ADDENDUM 6
REMEDIAL INVESTIGATION/FEASIBILITY STUDY
WORK PLAN

Lehigh Valley Railroad Derailment Superfund Site
LeRoy, New York
Index Number CERCLA-02-2006-2006

November 20, 2012

Figure 3-3a

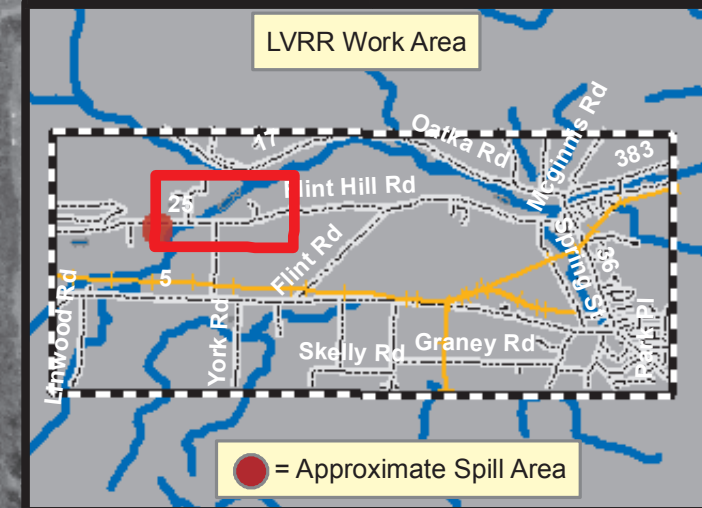
UMC proposes to collect surface water samples from Spring Creek and Mud Creek to obtain additional data regarding surface water quality with respect to the LVRR TCE plume. A spring water sample collected the falls on Mud Creek in January 2012 contained 57 µg/l of TCE. This location is above the Dintroff pond. Samples collected from below the pond dam during 2009 did not contain reportable concentrations of TCE. These two locations, LVRRSW-08 and LVRRSW-55, will be sampled again to evaluate the current water quality and evaluate if the surface water quality has changed over time. The attached Figure 3-3a from the Reconnaissance

Investigation Report shows the sampling locations. The spring water samples were collected in the same locations as the sediment samples. Surface water sample LVRRSW-08 was collected at the same location as LVRRSD-08.

FIGURE 2

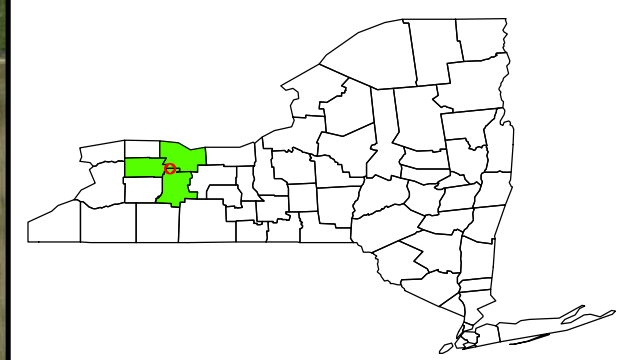
UMC proposes to collect a supplemental groundwater sample from LVRR-38C and a sample from the residential well located at 5 Guthrie Road in Caledonia, NY. The groundwater sample from LVRR-38C contained an estimated concentration of TCE (0.27 µg/l). This well is in line with the wells at the NYSDEC Fish Hatchery (LVRR-25). The residential well at 5 Guthrie Road is located between LVRR-25 and LVRR-38. The attached Figure 2 for Addendum 5 shows the locations of the monitoring wells. The residential well is located south of LVRR-40 and west of LVRR-38. The estimated TCE detection at LVRR-38C may not be real or it may be the horizontal extent of the plume. To assist in evaluating this, and to determine the water quality of the drinking water well, LVRR-38C should be re-sampled and the water in the residential well at 5 Guthrie should be tested.

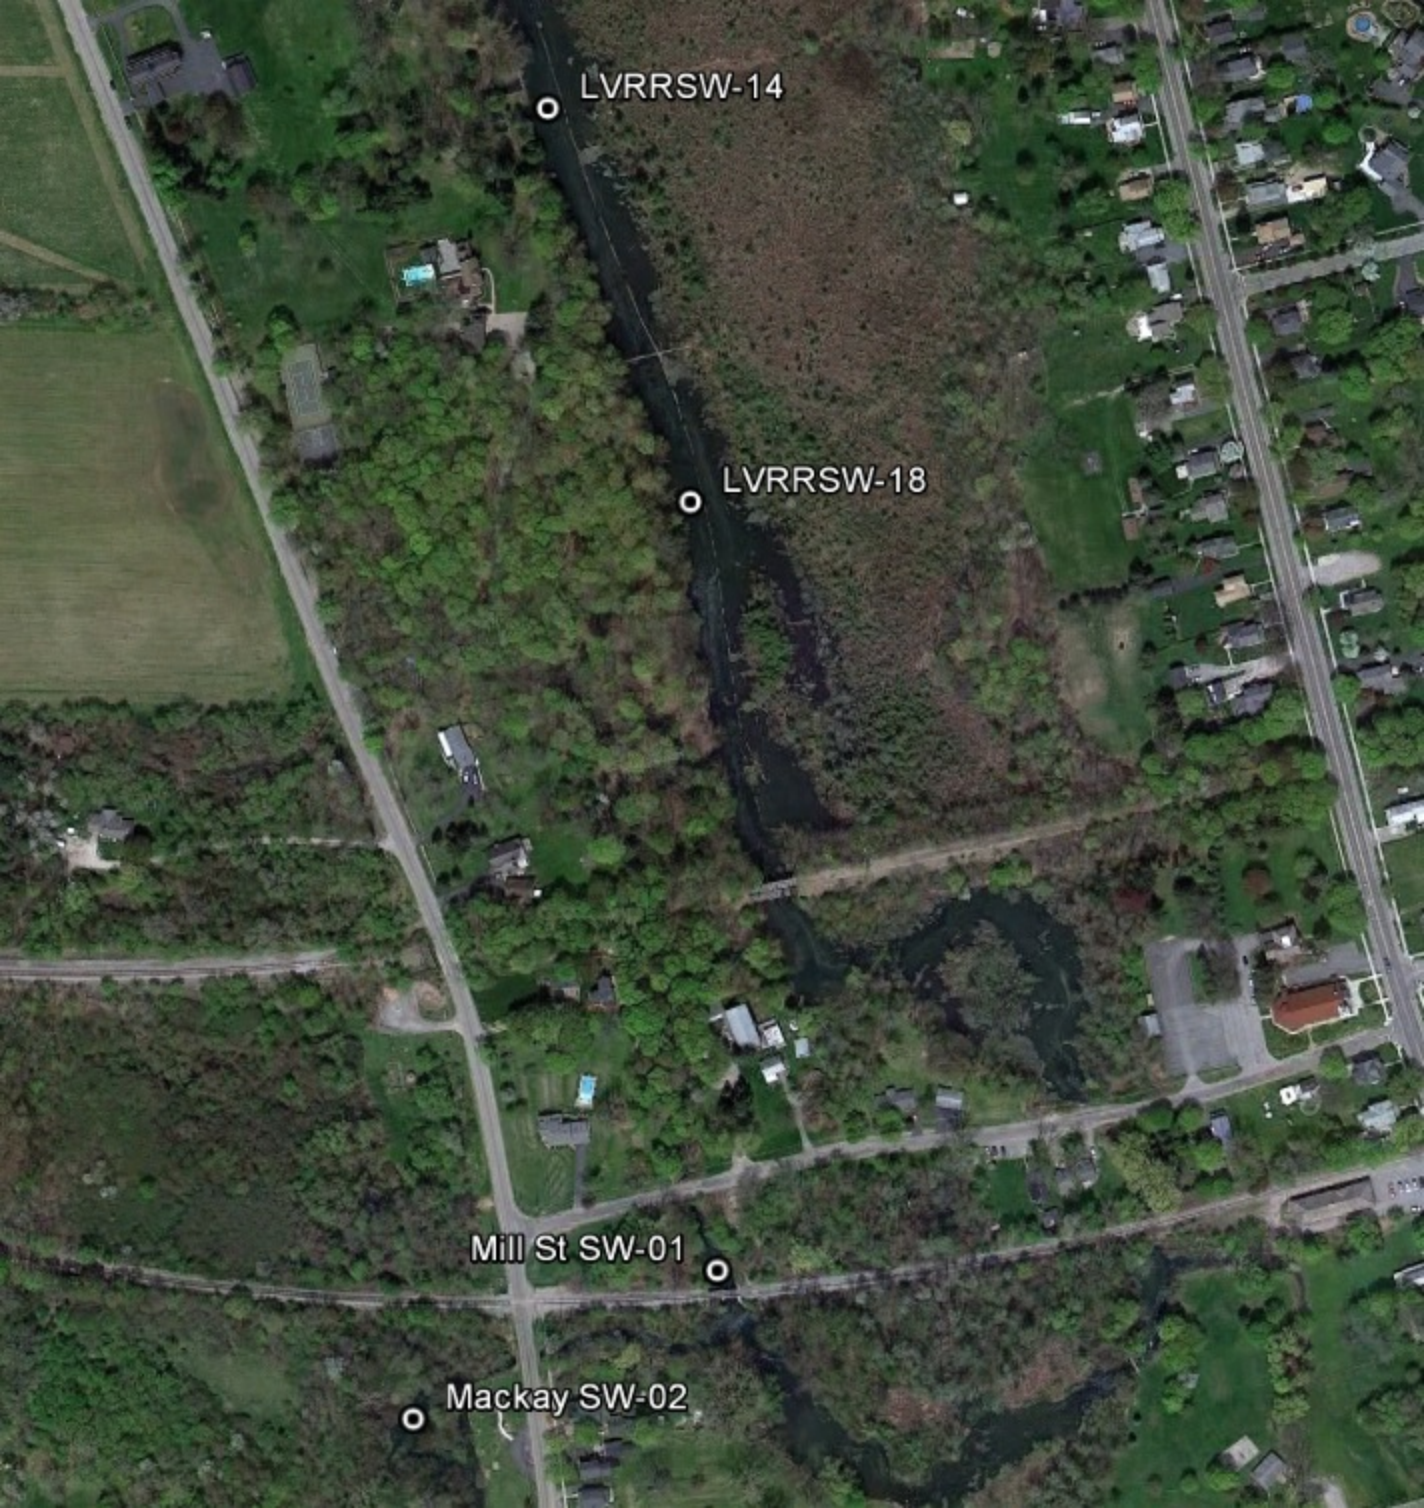
UMC collected surface water samples along Spring Creek during 2009 and again during January of 2012. UMC proposes to collect 12 surface water samples along Spring Creek, 7 of which will be from locations where surface water samples were previously collected. The 5 new locations will be located west of LVRR-24 for a distance of approximately 3000 feet. The samples will be collected at 500-foot intervals to provide data on the water quality and identify if any springs may be contributing dissolved TCE to the stream. The attached map of Spring Creek shows the surface water sampling locations.
